SUBDIVISION REPORT - CONCEPT/DEVELOPMENT PLAN

► **FILE #:** 8-SB-26-C **AGENDA ITEM #:** 26
8-B-26-DP **AGENDA DATE:** 8/13/2026

► **SUBDIVISION:** CARTER VALLEY (FORMERLY CARTER MILL, PHASE 9)

STAFF RECOMMENDATION:

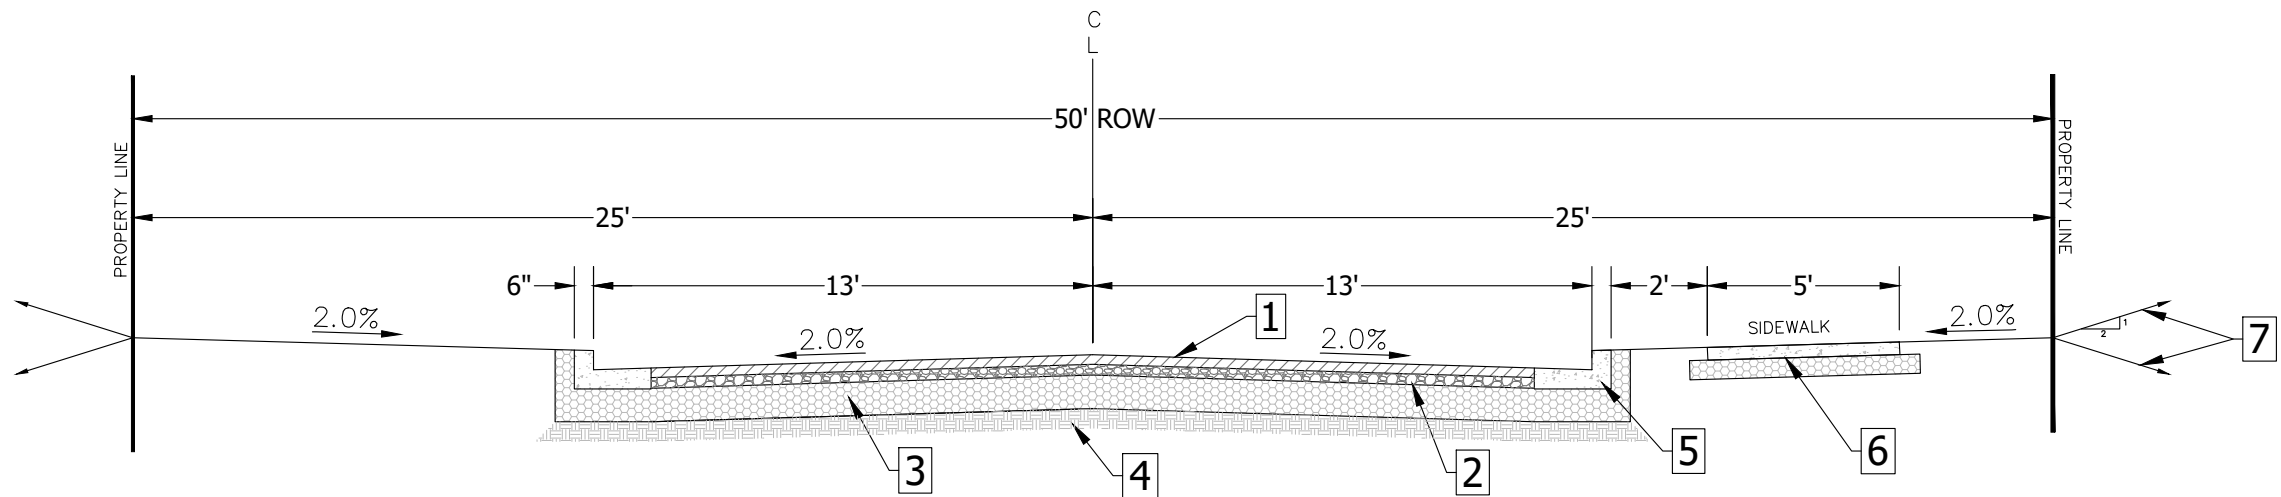
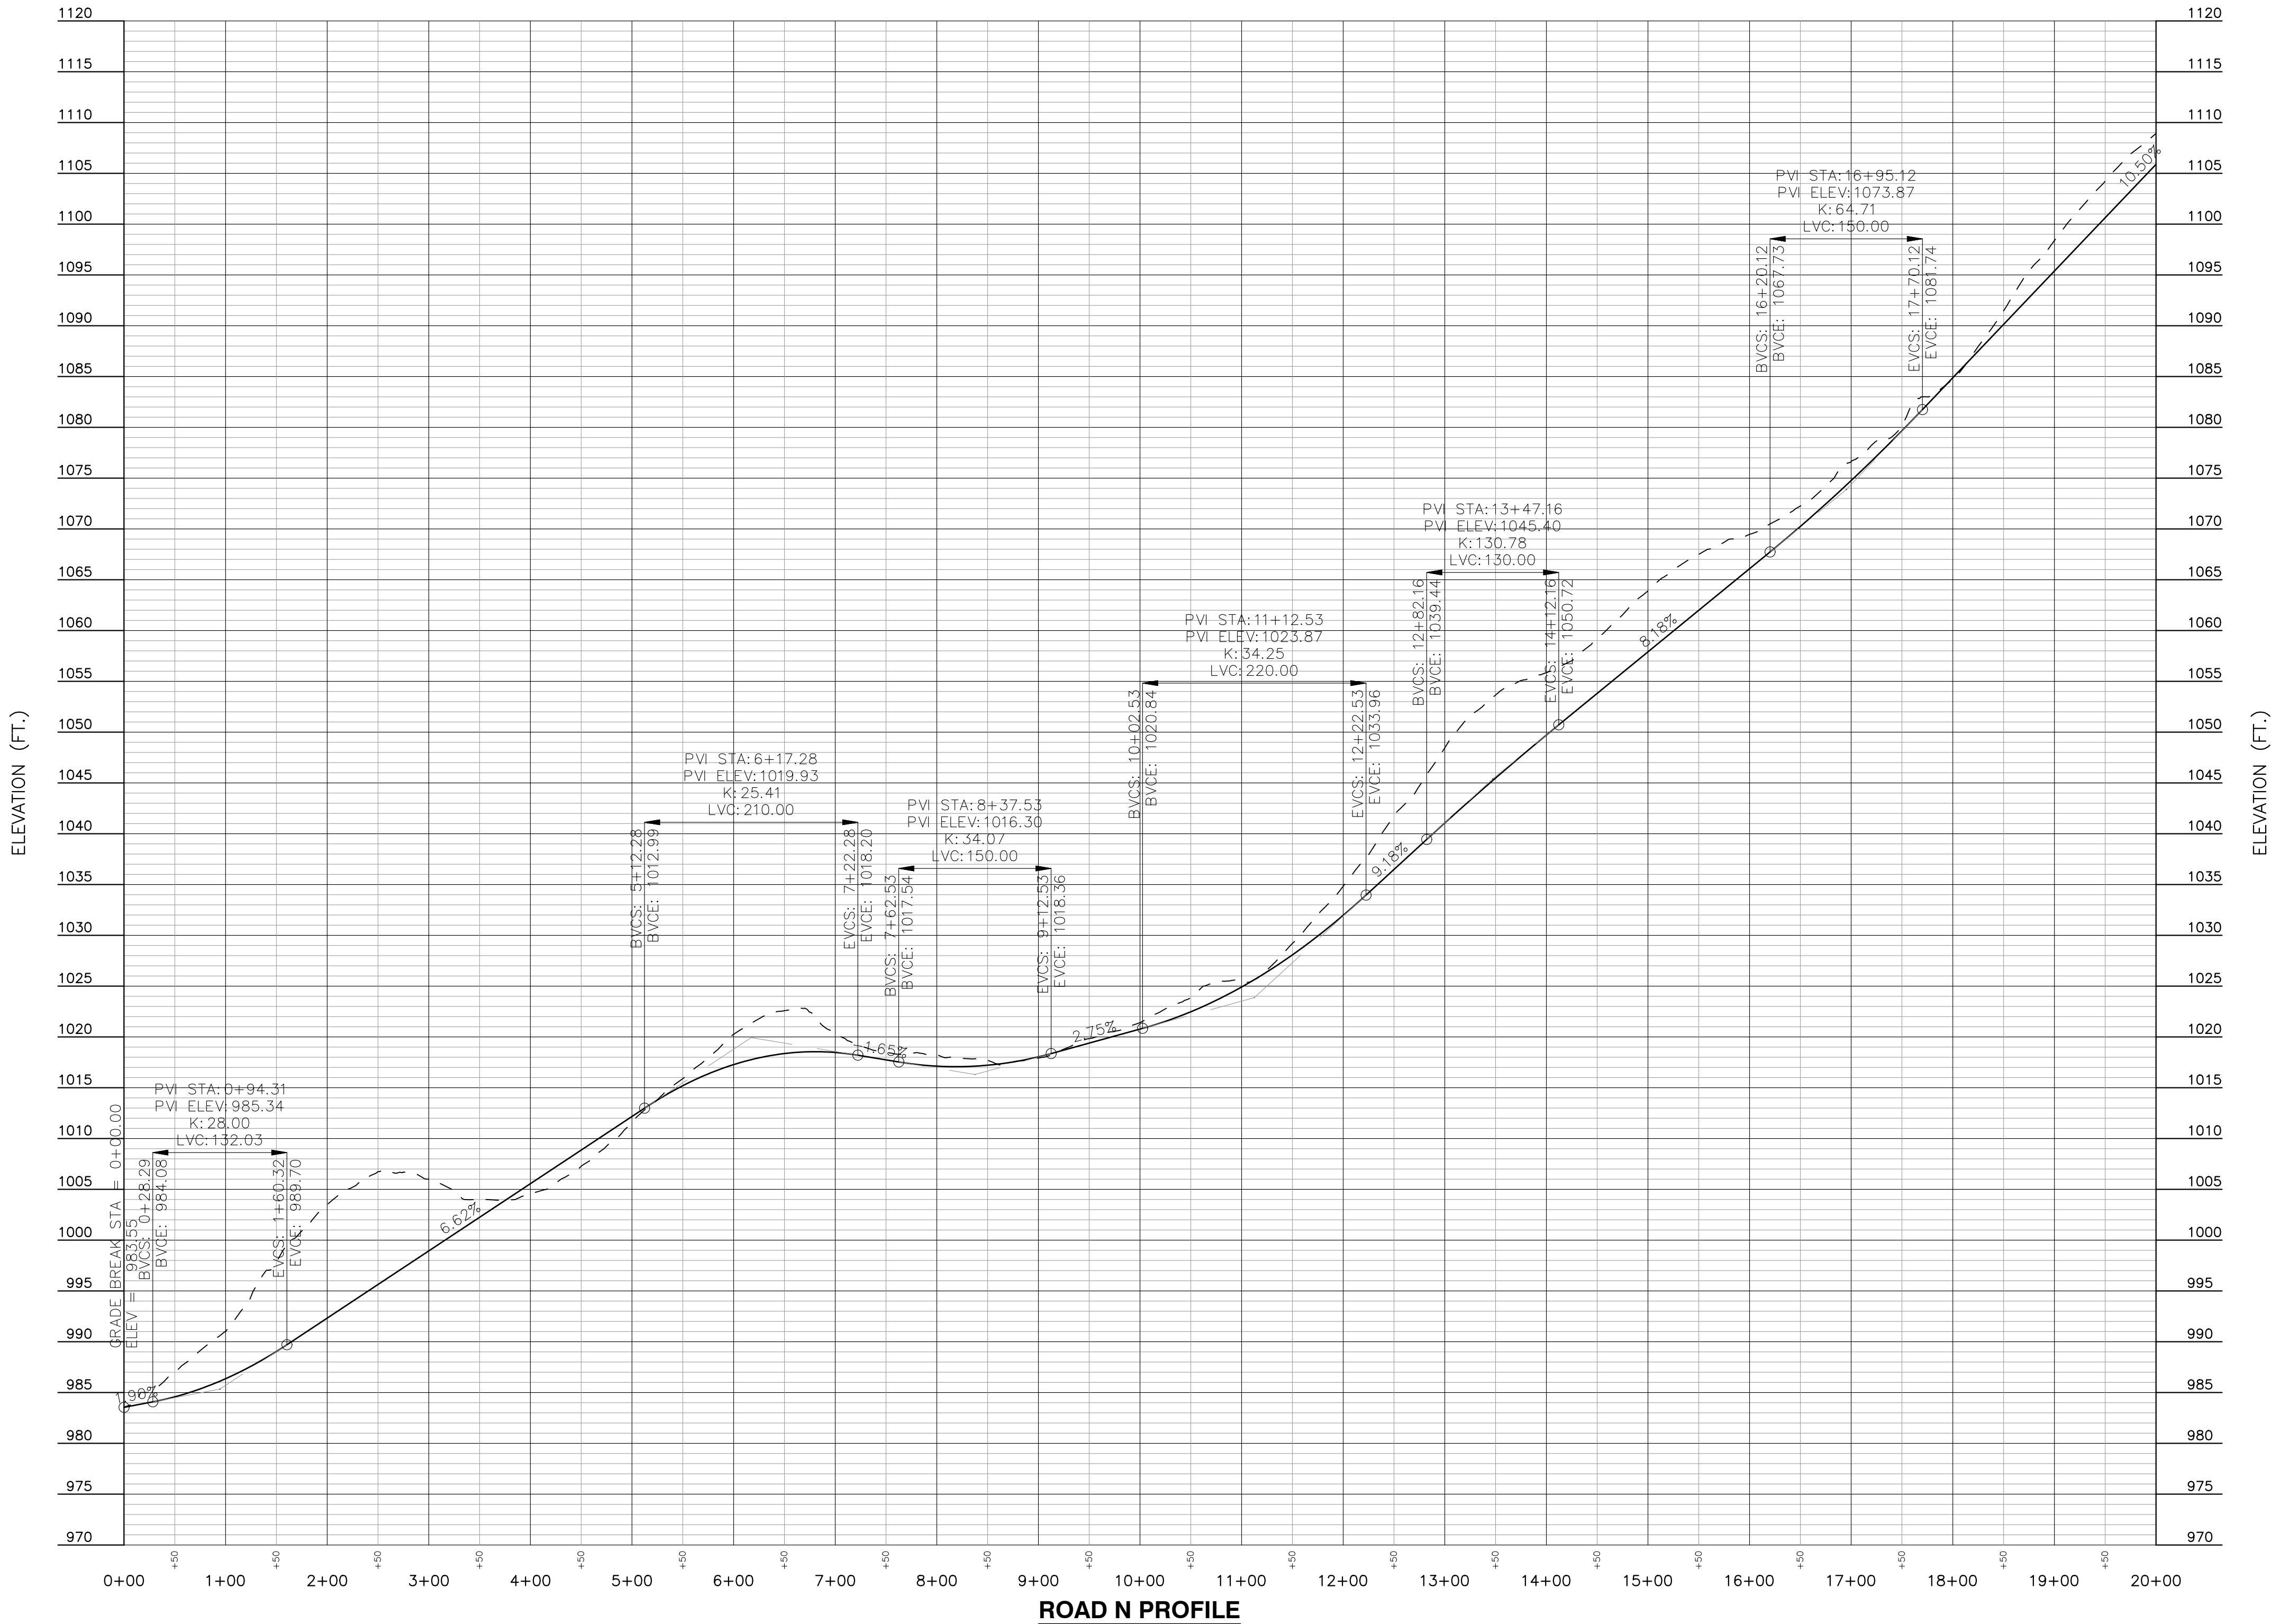
ALTERNATIVE DESIGN STANDARD REQUIRING KNOX COUNTY ENGINEERING AND PUBLIC WORKS APPROVAL (PLANNING COMMISSION APPROVAL NOT REQUIRED)
1) Increase the maximum intersection grade of Road 'N' from 1 percent to 2 percent at Carter Mill Road.

2) Increase the maximum intersection grade of Road 'O', Road 'P', Road 'Q', and Road 'R' from 1 percent to 2 percent at Road 'N'.

Increase the minimum intersections grade from 1% to 2% at the intersections of Road P at Road N, Road Q at Road N, Road O at Road N, and Road N at Carter Mill Drive.

Engineering supports the alternative design standard requested

APPROVED

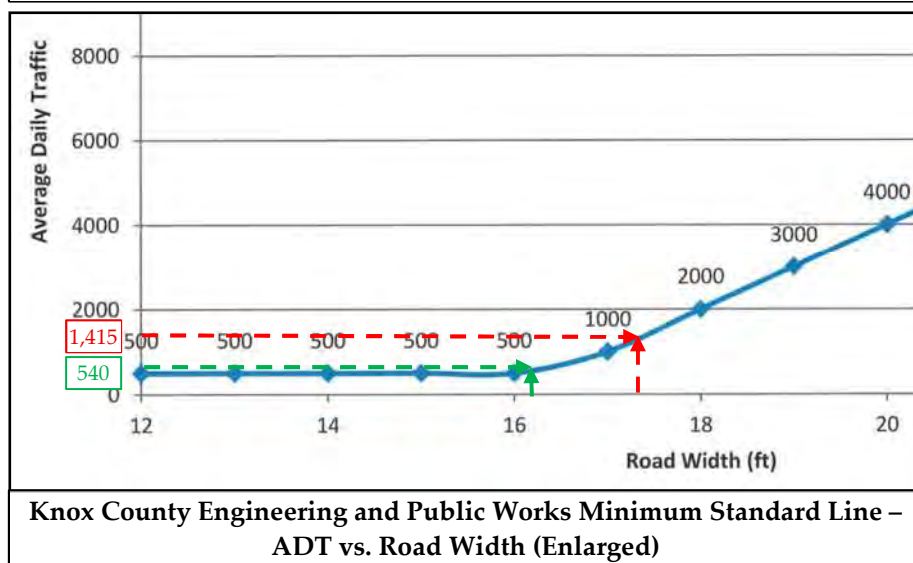
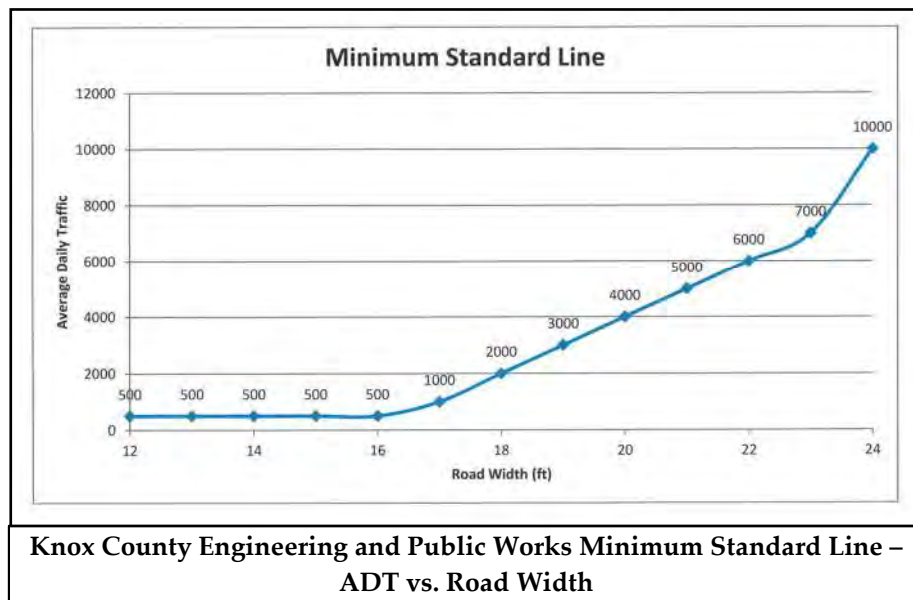
Carter Mill Drive: As discussed and described previously, the western section of Carter Mill Drive is narrow in width and difficult to safely traverse with vehicles simultaneously traveling in opposite directions. This narrow width is outside of the portion that was widened to 20 feet to allow for the initial development of the Carter Ridge Subdivision. This western section of Carter Mill Drive also has other issues outside narrow road widths that are problematic for safe travel with ever-increasing volumes.

The average width of the western section of Carter Mill Drive (west of the Proposed Entrance location for Phase IX – approximately 3,545 feet) was calculated to be 15.7 feet and has limited shoulders outside the pavement, faded to non-existent pavement markings, limited warning road signage, possibly substandard sight distances when vegetation is growing and unmaintained, pavement edge drop-offs, and the pavement surface on this section appears to be approaching the end of its useful life. The narrowest pavement width measured on the western section of Carter Mill Drive was 13.6 feet.

Carter Mill Drive's western section will require improvements to safely and effectively serve both current and future users. Demand on this roadway is currently relatively light. Still, it is expected to increase with each subsequent phase of the Carter Ridge Subdivision being constructed and general background traffic growth in the area. Any improvements must carefully balance safety considerations with the corridor's physical constraints. Providing an improved roadway that balances the need for safe vehicle passage with the surrounding terrain and existing alignment requires careful engineering judgment and trade-offs.

Therefore, widening the western section of Carter Mill Drive to a target width of 18 feet is recommended as the ultimate goal by the time all phases of the Carter Ridge Subdivision are completed and occupied in 2029. This width will provide adequate capacity and improved safety for projected traffic volumes. Widening this section beyond 18 feet to a full 20 feet to match the eastern portion of Carter Mill Drive could be considered impractical in many locations due to the more aggressive terrain, winding horizontal alignments, and right-of-way constraints present on the western end. Widening beyond 18 feet could also encourage higher vehicle speeds, which would be incompatible with the existing geometry, steep grades, and roadside hazards.
